Product Change Notification.

PN Number:	PN26-061	**Date:**	11.09.2026
Revision:	0	**Author:**	Ricardo Alves Prado

Product class:	Stud diodes
Subject of change:	Internal packaging change for small stud diodes

Improved packaging:

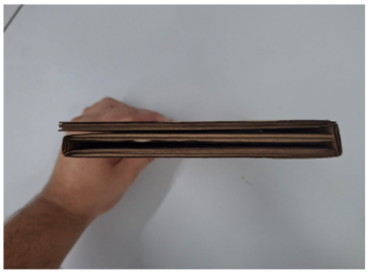
The standard cardboard is being replaced with a reinforced triple cardboard structure, increasing packaging robustness to transport and humidity.
Diode fixation was also improved, holes in the cardboard used to insert the diodes are being modified from a "star" to a "X" shape, granting better grip over the diode thread.

Reason:	Package improvement for increased reliability during transport and handling
Impact:	No impact on product, external box dimensions will remain the same
Identification:	
Qualification:	Handling and drop test - Results under request
Supporting Documents:	n.a.
